APPLICATION NO.	FILING DATE	FIRST NAMED INVENTOR	ATTORNEY DOCKET NO.	CONFIRMATION NO.
10/662,200	09/11/2003	Gary C. Vanstone	EM-1991	9114
5179	7590	05/10/2005	EXAMINER	
PEACOCK MYERS AND ADAMS P C			NGUYEN, THONG Q	
P O BOX 26927			ART UNIT	
ALBUQUERQUE, NM 871256927			PAPER NUMBER

Office Action Summary

DETAILED ACTION

FIG. 2

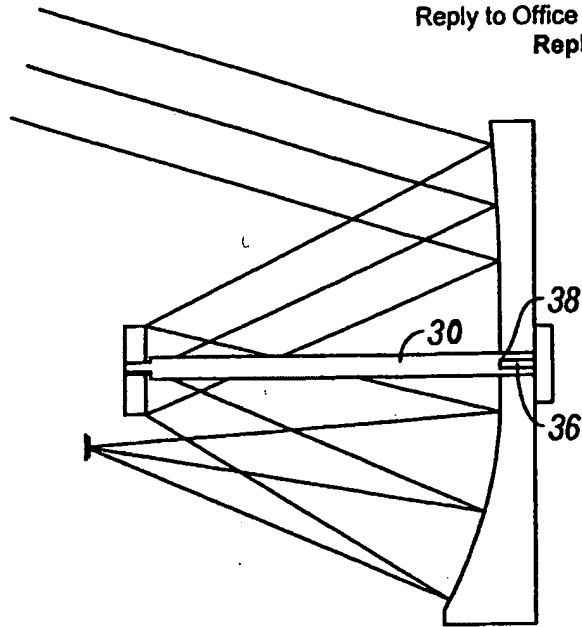
2. The drawings contained corrected figures 2-3 was received on 3/3/2005. These drawings are approved by the Examiner.
